No. 93-4

A. REQUIRED FLAME ARRESTOR REPLACEMENT

MCM 5.7L Alpha Stern Drive Engines Only
Serial Number: 0F000455-0F010698

a - Vent Hose Cross Piece

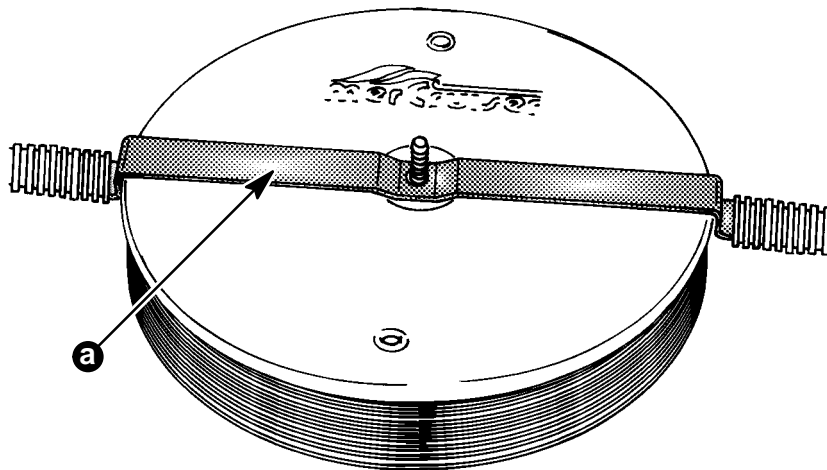
This engine had the wrong model flame arrestor installed. This will cause the engine to run rich.

Remove cover and look at the flame arrestor.
Without vent hose cross piece - wrong type, must be changed.
With vent hose cross piece – correct type, do not change.

(1) 805298A1 Flame Arrestor
